**Twilight Road Cleanfill, Clevedon
Detailed Design Road Safety Audit**

Project: Twilight Road Cleanfill, Brookby
Report title: Detailed Design Road Safety Audit
Document reference: J00539 Twilight Road Cleanfill RSA-final
Date: 20 December 2016

Photograph 4: Power Pole at ch. 720

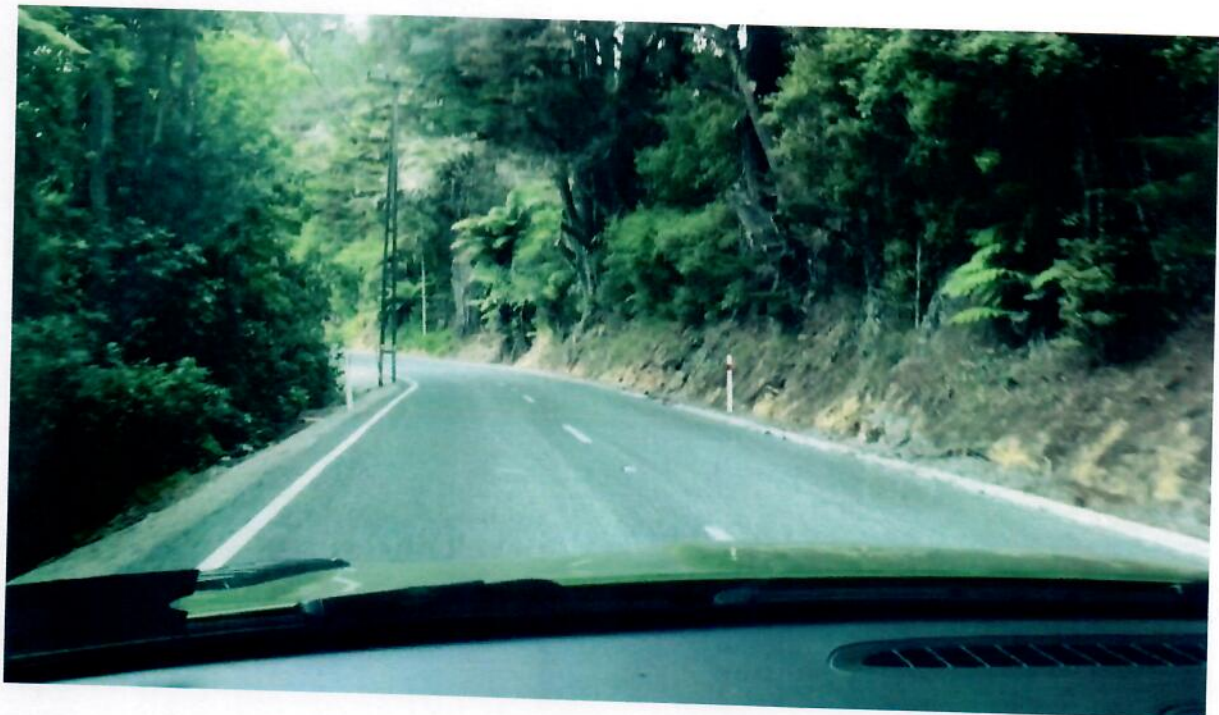
Power poles on the northern side of Twilight Road are located in very close proximity to the carriageway. The SAT is concerned that vehicles travelling eastbound on Twilight Road may be travelling at higher speed (due to the road widening) and potentially collide with these poles.

- Poles on outside of curve and vehicles potentially losing control and colliding with pole. These poles are located near ch.660, Ch. 760 and ch. 860 – ch. 940.
- Poles on the inside of curve and vehicle potentially cutting the corner and colliding with pole. In some cases the poles did not have any hazard reflectors to warn vehicles of the pole during the night. These poles are located at ch. 720, ch. 1060 – ch. 1100 and ch. 1160. The pole at ch. 1160 appears to be new.

- Provide hazard reflectors on all poles.
- Provide cold applied markings with audio tactile profile to provide delineation for vehicles at night.

- Consider limiting speeds through this section of road (either through speed advisory signage or regulatory signage).

Frequency Rating: Crashes are likely to be Occasional	Severity Rating: Death or serious injury is Very likely
Designer Response: Hazard reflectors have to be added to all power and telecommunication poles where they were missing. Advice from Ross Roadmarking is that ATP markings on chipseal get dislodged and so we do not consider it practical to apply. Speed limit restrictions were discussed with Auckland Council and would be a matter for Auckland Transport.	
Safety Engineer:	Click here to enter text.
Client Decision:	Agreed to install new hazard markers on poles where they are missing
Action Taken:	Hazard markers have be installed.
